APICAL INDUSTRIES, INC.
dba DART AEROSPACE

ENGINEERING CHANGE NOTICE NO.

05397

DWG TITLE: STRUT ASSY

SHEET 2, ZONE D4 IS:

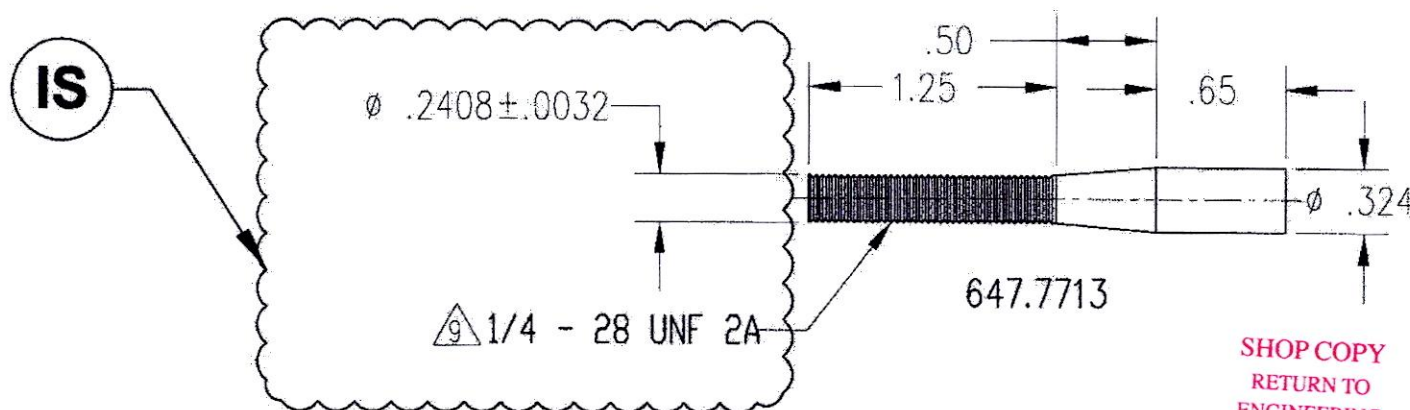
REASON: REVISED DIMENSION

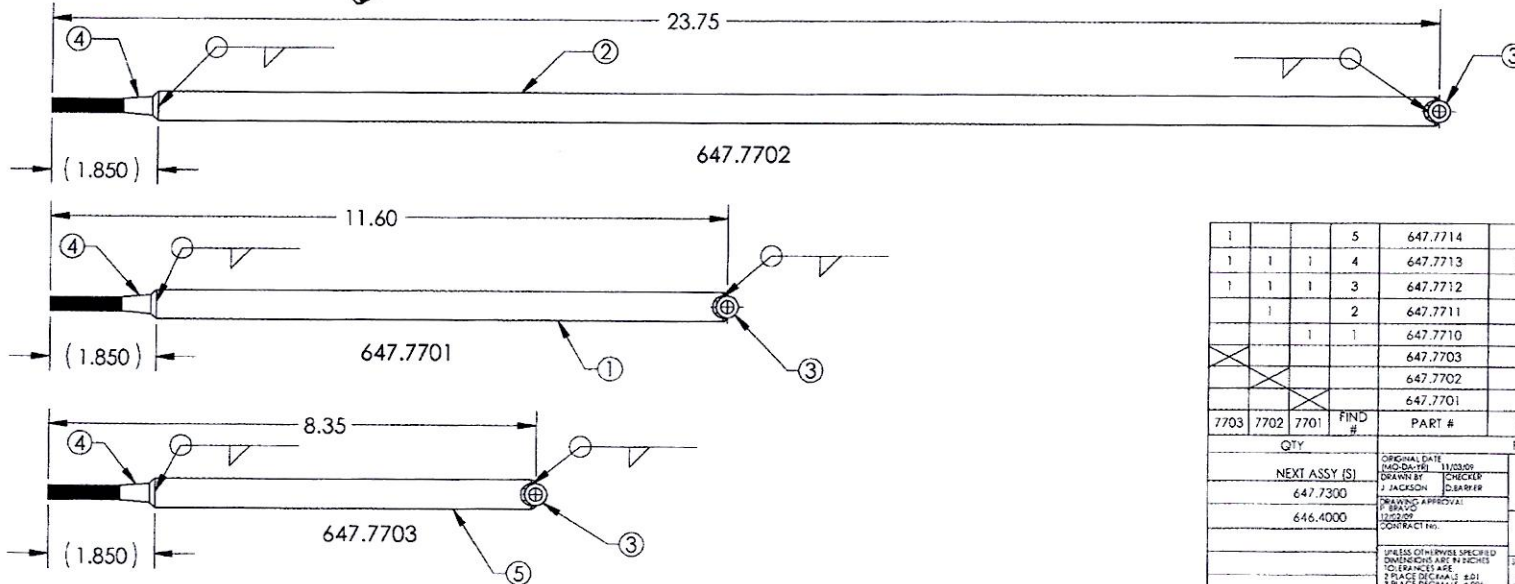
REASON: REVISED FINISH CALLOUT AS PER ECR 15-209

SHEET 1, NOTES IS:

- 1 MATERIAL: 4130 STEEL PER AMS-T-6736, .50" OD, .083" WALL THK.
- 2 MATERIAL: 4130 STEEL PER AMS-T-6736, .375" OD, .075" WALL THK.
- 3 MATERIAL: 4130 STEEL PER AMS-T-6736, .324" OD.
- 4 FINISH: PRIME IAW MIL-P-2337J TYPE I CLASS N; 1-2 MIL MAX
5. DEBURR AND BREAK ALL SHARP EDGES
6. IDENTIFY IAW MPP-120.
- 7 WELD IAW MIL-STD-2219. TIG WELD WITH FILLER ROD
- 8 FINISH: CAD PLATE IAW QQ-P-416F CLASS I TYPE II
- 9 MASK THREAD PRIOR TO FINISH
